Date Issued :	April 05, 2023	PCN Number :	513032
Reason for Change :	Change to Product		
Description of Change :	The change is at the customer request due to a problem that coupling nut is falling out from the shell. - Spring ring 1203180090 dimension change to 0.9x0.9 - shell 1203180450 added dimension 45 for edge - nut 1203180089 changed tolerance for dim 1 to -0.2		
Reason for Short Notice :	Corrective Actions		
Assessment of Change :	First Article Inspection		
Planned Implementation Date :	August 25, 2023		
Sample Availability Date:	July 19, 2023		
Internal Molex Qualification Date :	July 19, 2023		
Last date to request Samples by Customer :	July 24, 2023		
Traceability Code Markings / Date :	No special marking on the product or packaging

Overview

Before Picture

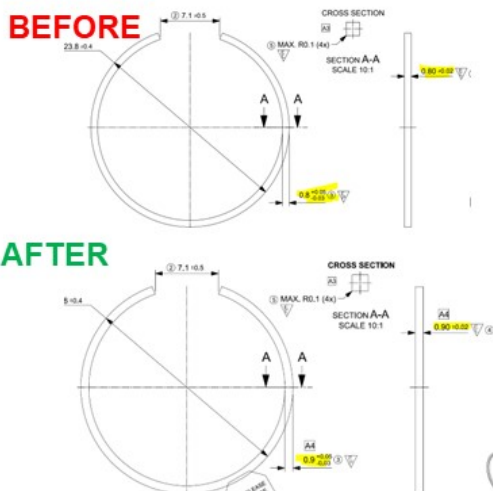
Changing dimensions of spring ring

Adding dimension for edge

Changing tolerance

- The change is at the customer request due to a problem that coupling nut is falling out from the shell.
 - Spring ring 1203180090, dimension change to 0.9x0.9
 - shell 1203180450, added dimension 45 for edge
 - nut 1203180089, changed tolerance for dim 1 to -0.2
- Product Impact
 - Increasing the strength of the product.
- Part Number Impact
 - 1203180090
 - 1203180089
 - 1203180450
